## Planning Commission AGENDA

Originator Planning	Item <b>Clover Center Redevelopment: Rezoning, PDP/FDP, 9728 Lyndale Avenue</b>
Agenda Section Item 1	Date October 14, 2021

Rezone 9728 Lyndale Avenue South to apply the planned development (PD) overlay zoning district, preliminary development plan for a multi-phased redevelopment of the Clover Shopping Center, and final development plan for a partial redevelopment of the Clover Shopping Center and to construct an approximately 24,000 square foot grocery store with site modifications

**Figure 9**  
*Recommended Site Plan Improvements*

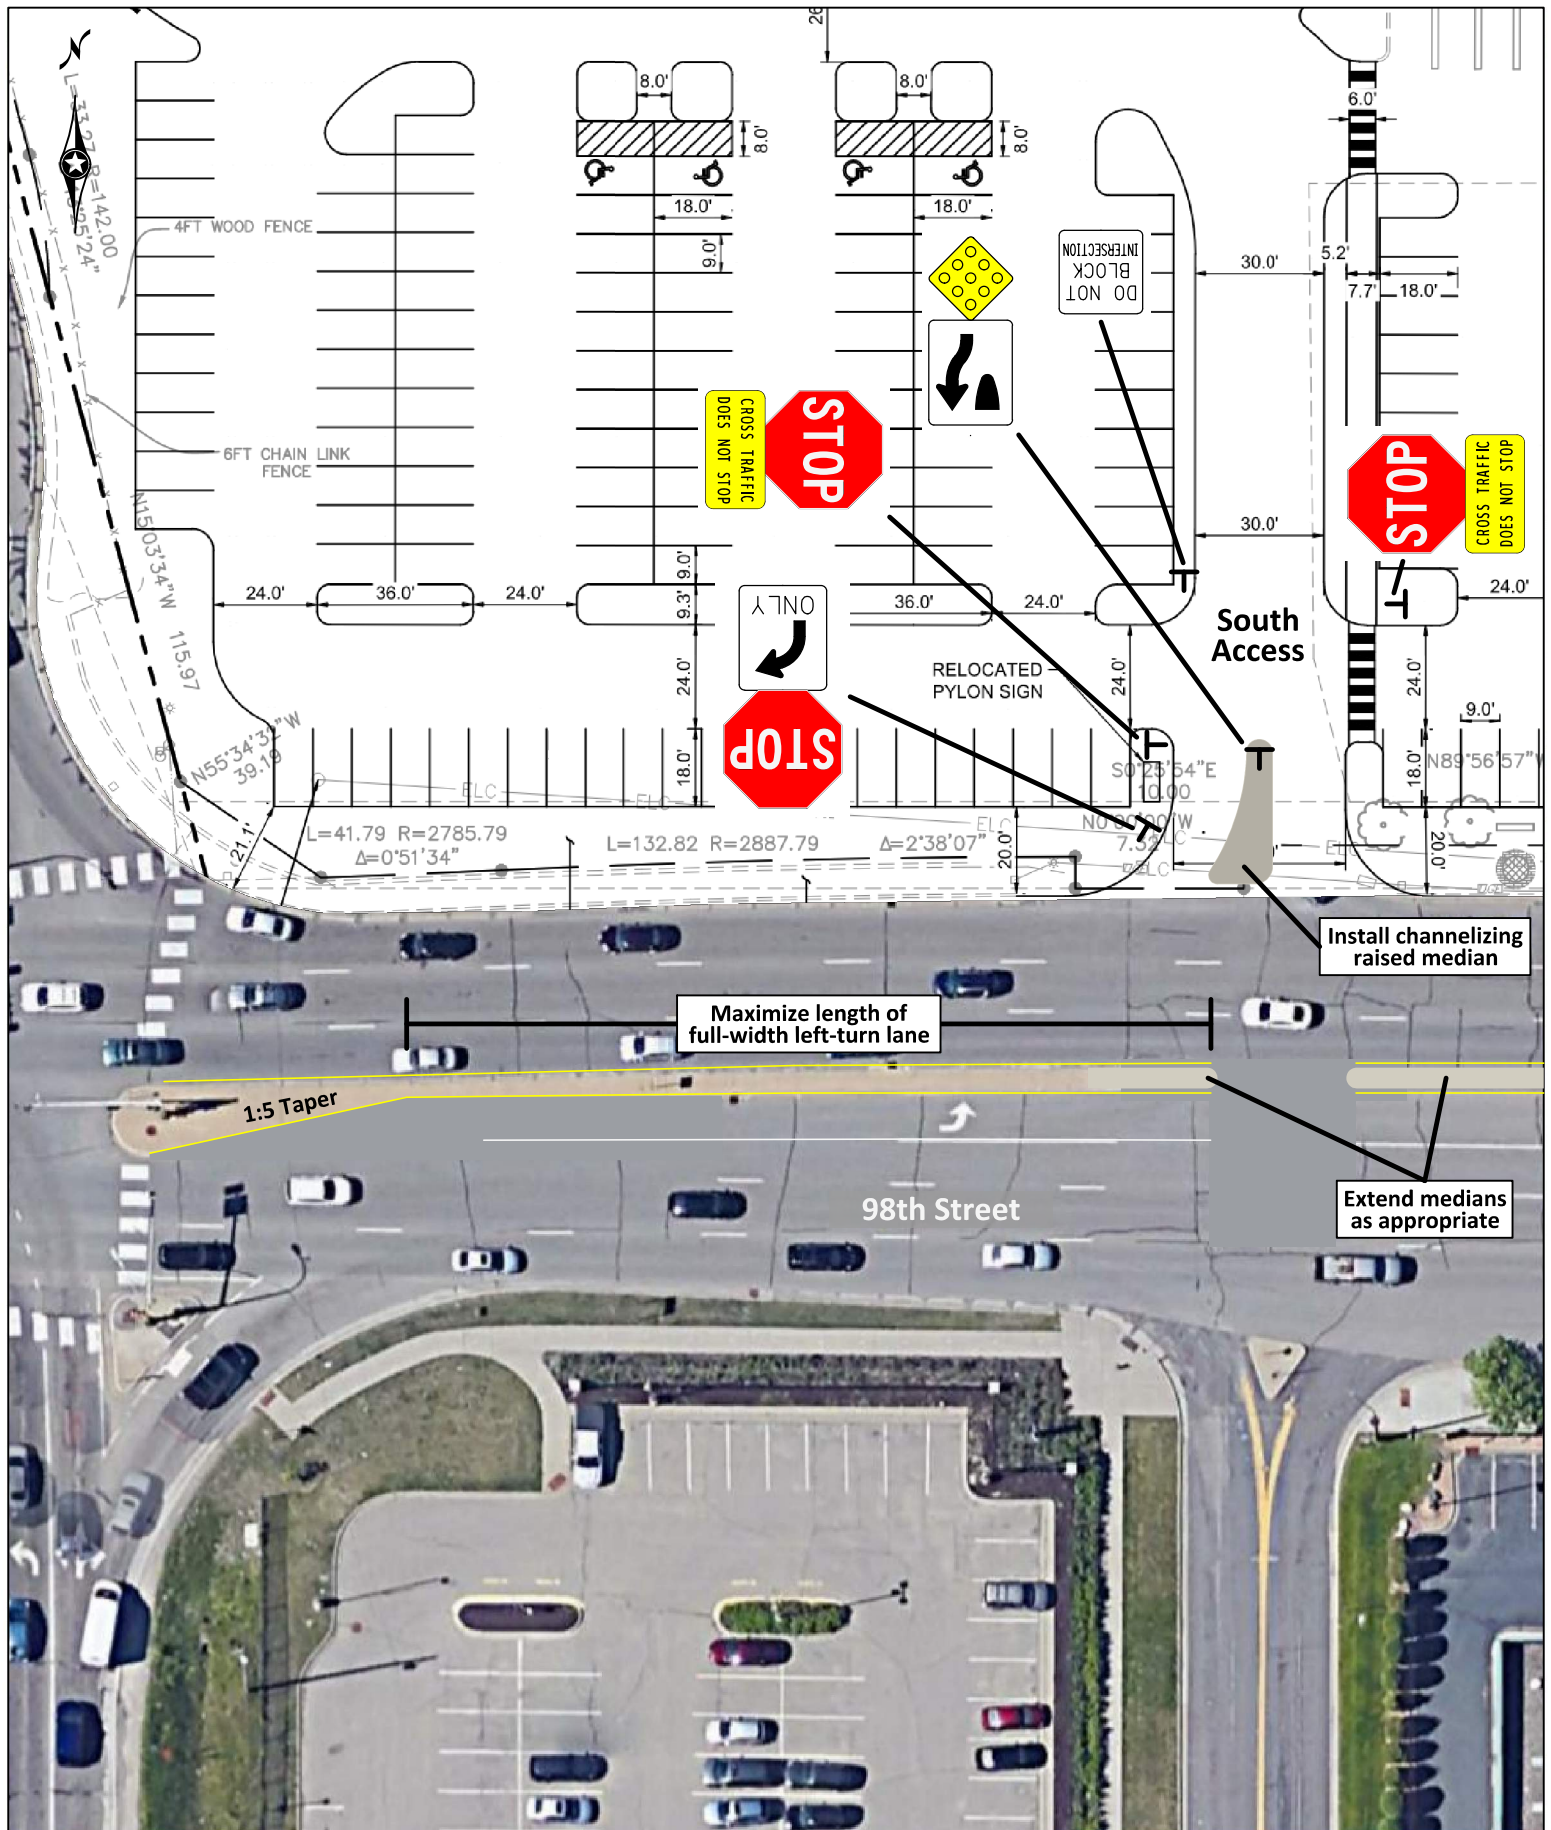
Figure 9 in the traffic study does not include recent improvements made at the east ramps of I-35W. As noted under the "Traffic" comment above, the channelized free-right has been removed and replaced with a standard right turn lane. This intersection adjustment has also shifted the location of the east leg crosswalk across 98<sup>th</sup> St further to the east. The taper for the left turn lane into the site's south access should not begin until after the new crosswalk.
